Keith Hay CC9 - BUN60382589, Response to Section 92 Request for Further Information

Further to your letter dated 19 August 2021 requesting further information pursuant to section 92 of the Resource Management Act 1991 (RMA), we write to provide a response to the matters outlined therein. The information requested is shown in *blue italics*, followed by our response. For ease of reference our numbering corresponds to the numbering set out in your letter.

CLIENT	WATERCARE SERVICES LTD		
PROJECT	KEITH HAY CC9		
TITLE	CONSTRUCTION VEHICLES TURNING OUT OF HILLSBOROUGH KINDERGARTEN		
SCALE (A3)	1:250	FIG No.	1015172.1400-F02
REV	1

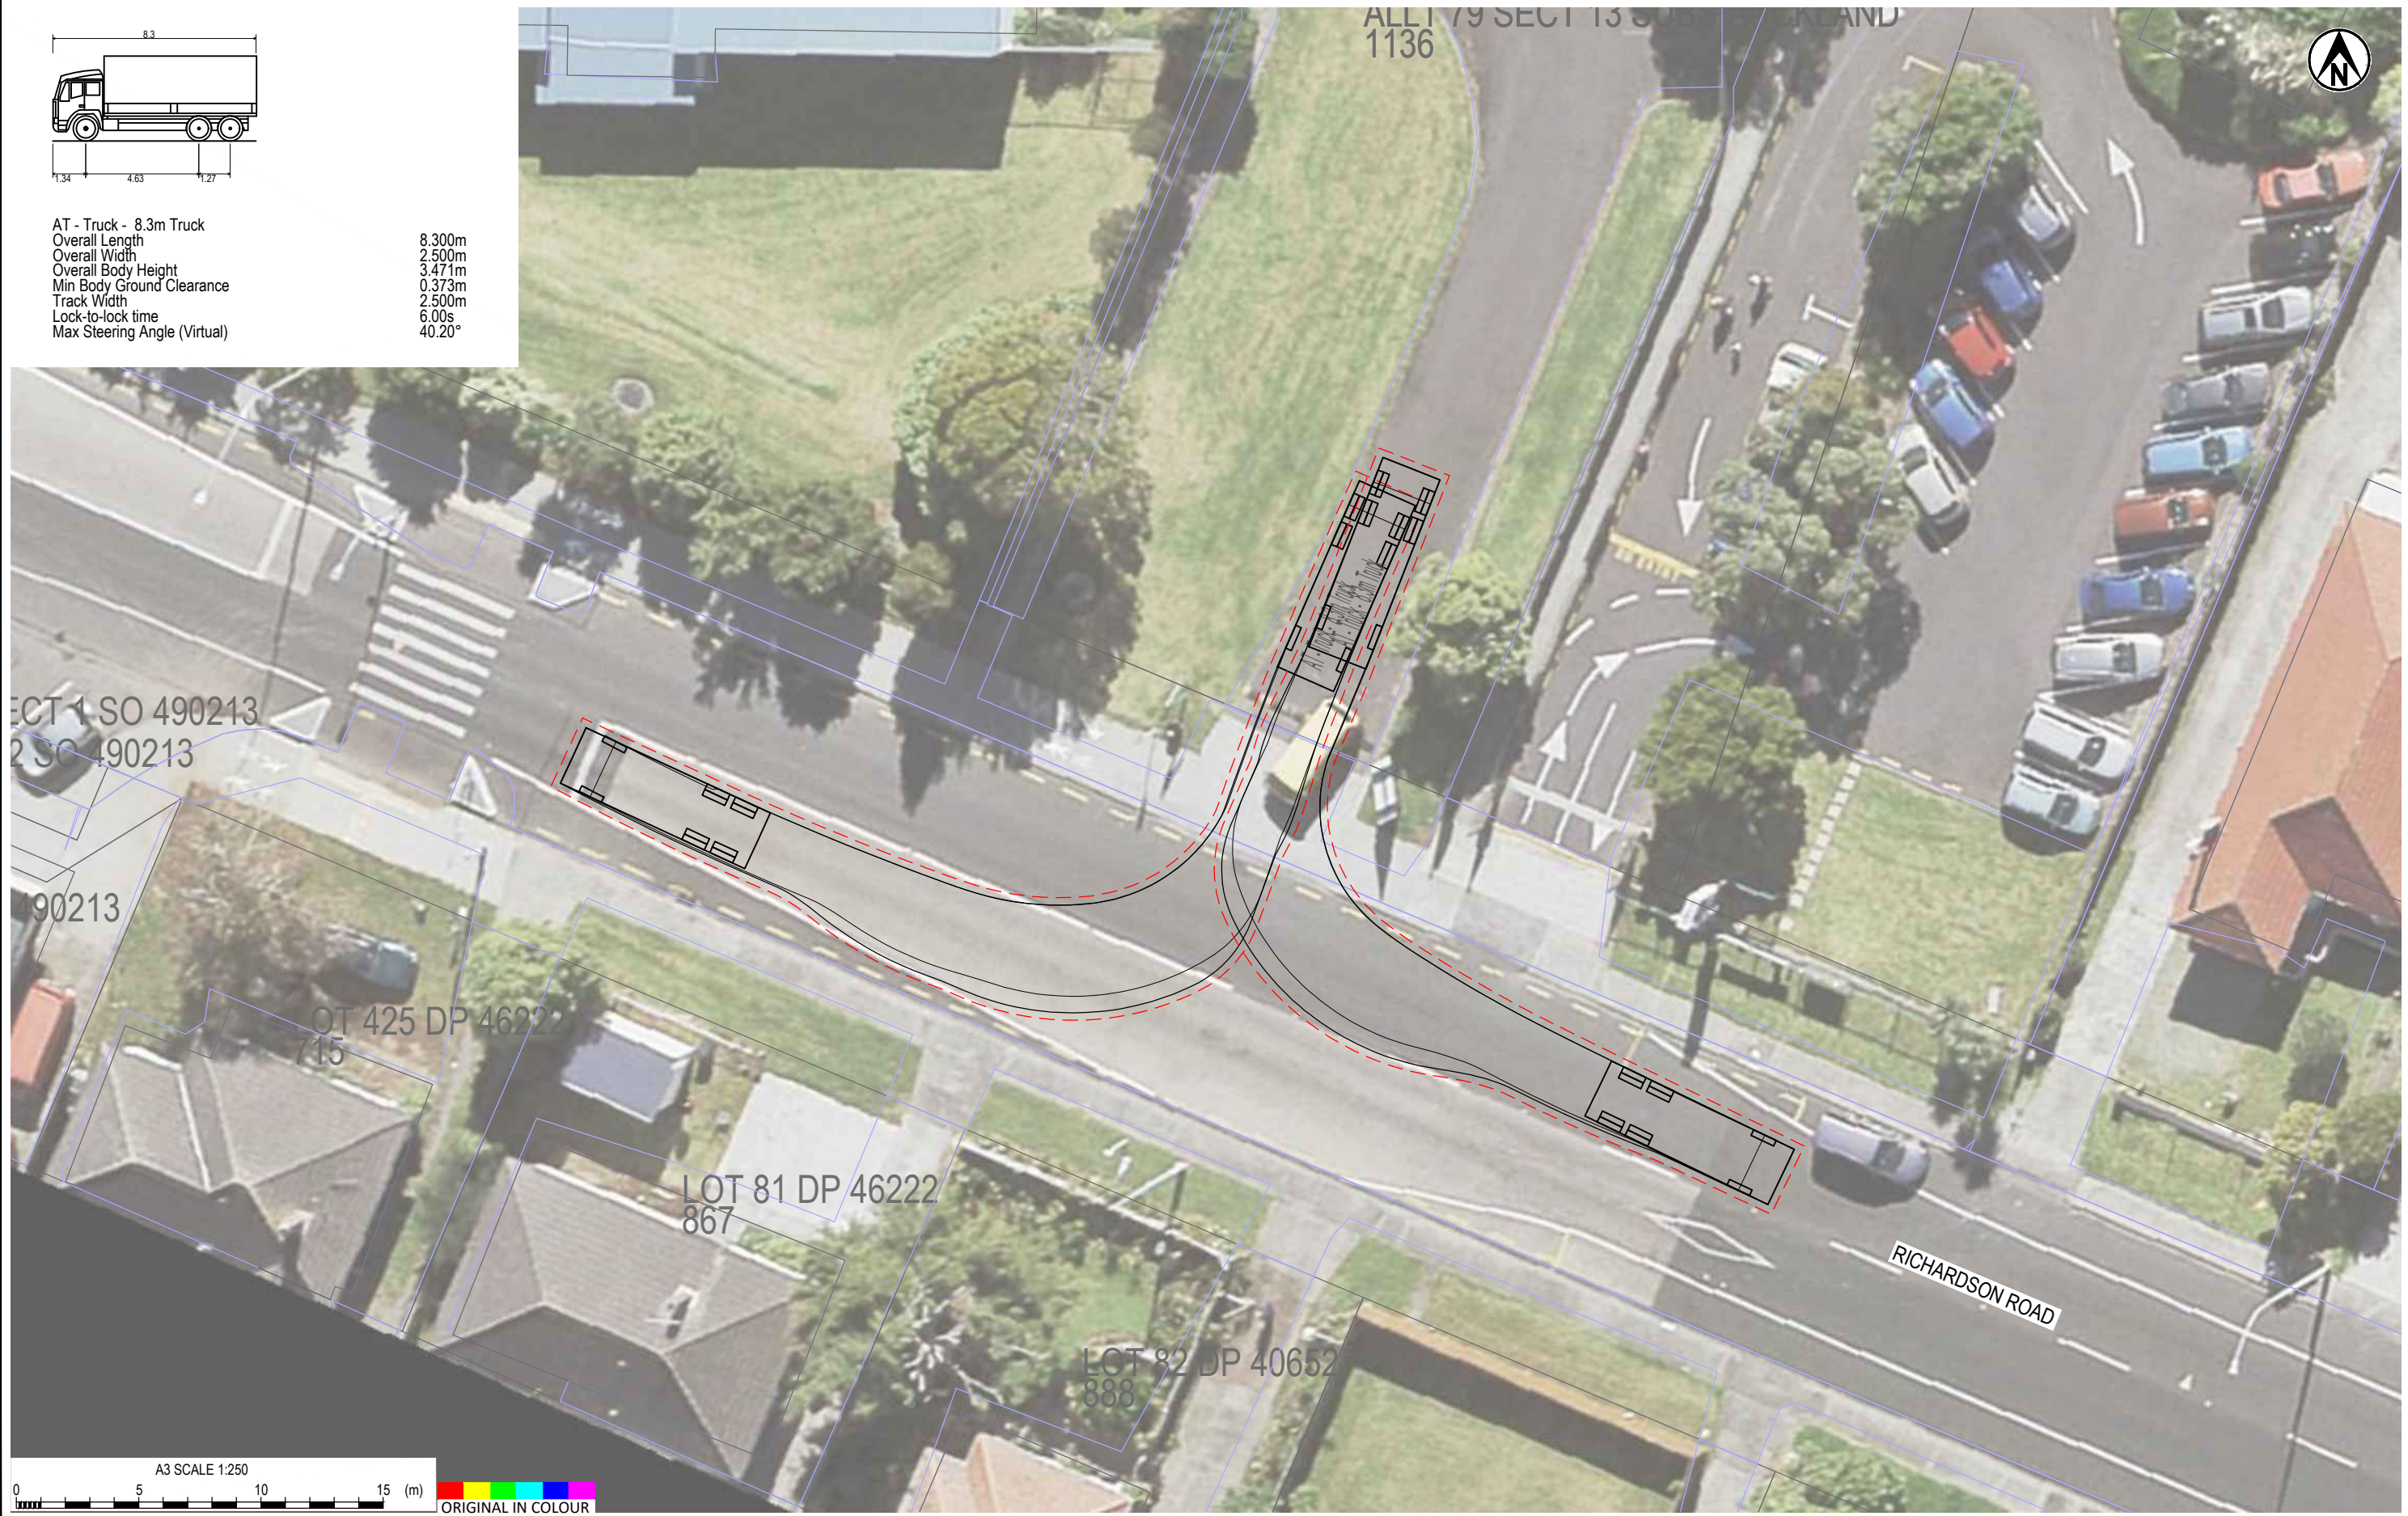
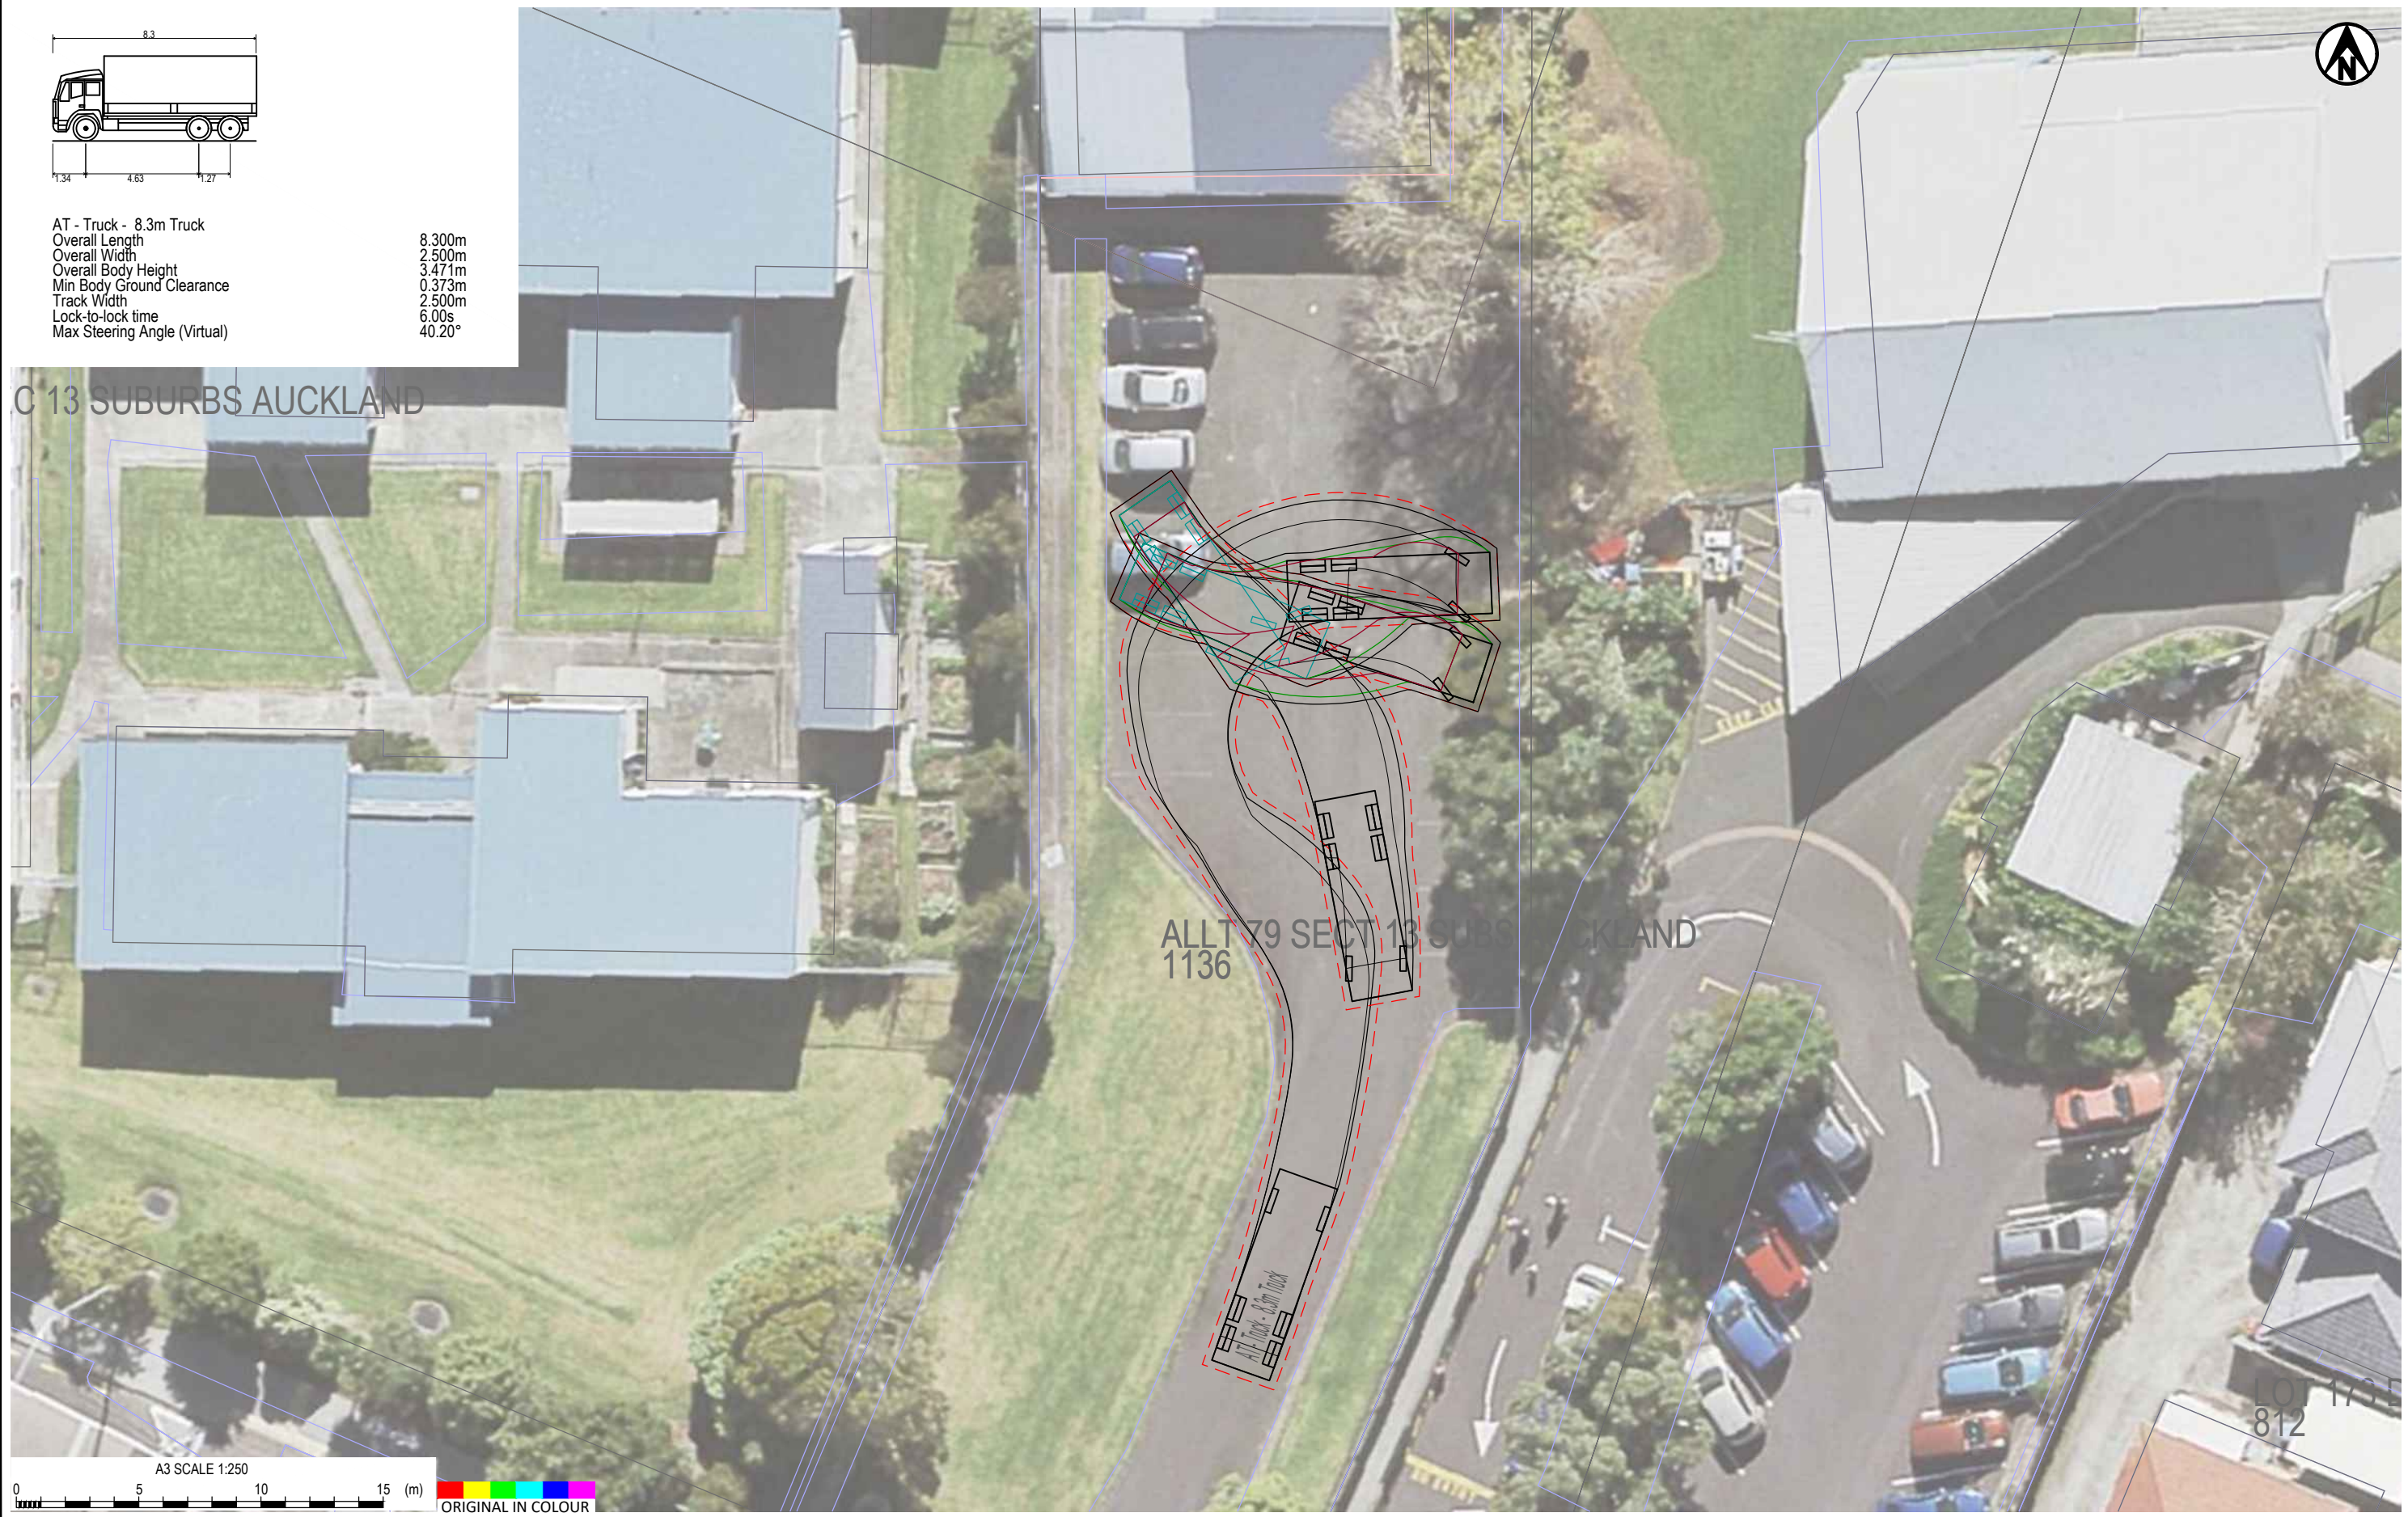
c. Given the relatively small size of this car park, please confirm if it will it be necessary for construction related vehicles to reverse manoeuvre onto the street? If reversing is required, please provide an assessment of the likely adverse effects, including the frequency of such manoeuvres and any necessary mitigation measures.

Using the Auckland Council GIS viewer surveys, the existing formed width of the vehicle access to Hillsborough Kindergarten was measured to be 6.4 m wide. Vehicle tracking has been produced (as shown in Figures 1015172.1400-F01 to F03 in Appendix B) to ensure that this can accommodate construction vehicles. The construction vehicle used is assumed to be an 8.3 m dump truck. Figures 1015172.1400-F01 to F03 in Appendix B show the dump truck entering, exiting and manoeuvring on the site. This shows that the existing access to Hillsborough Kindergarten can accommodate the construction vehicles.

An assessment of vehicle crossing and access against the relevant requirements of Chapter E27 of the Auckland Unitary Plan (AUP) is set out in Appendix B. Given that the existing carpark is approximately 17.5 m wide, construction related vehicles are expected to be able to turn within the carpark area rather than reverse manoeuvre onto the street.
